Technical Service Bulletin

40 Noises from the front axle and swivel joint (ball joint)

40 20 99 2058421/1 February 4, 2020.

Figure 1. Swivel (ball joint).

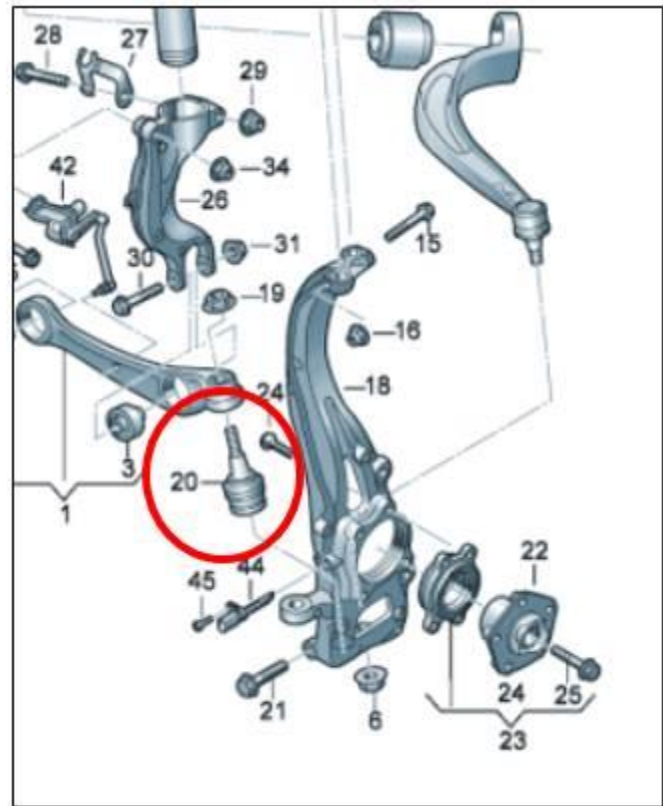
- The customer statement can be reproduced.
- The noises can be assigned to the swivel joint (ball joint) of the left or right front axle (Figure 1, pos. 20).

Identify and replace the affected swivel joint (ball joint) of the left/right front axle according to the instructions in Elsa at Repair Manual, *Chassis >> Suspension, Wheels, Steering >> 40 Front Suspension >> Lower Control Arm and Ball Joint >> Ball Joint, Removing and Installing.*

Figure 2. Example of initial production date of week 36/19.

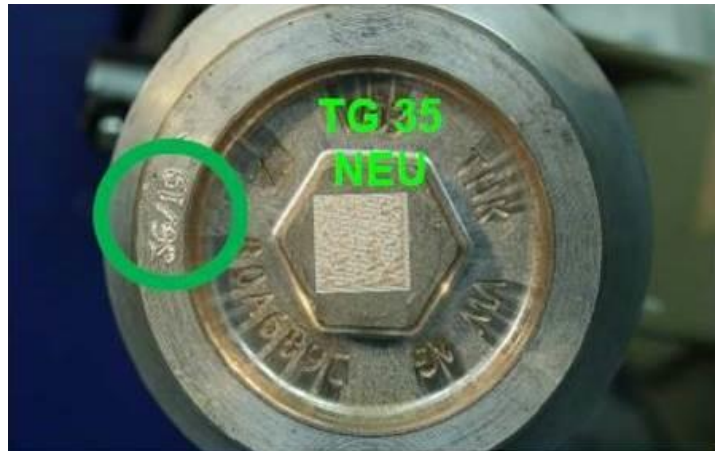
Make sure that the new parts you are installing have production date week 36/19 or later (Figure 1 and 2, green circles).
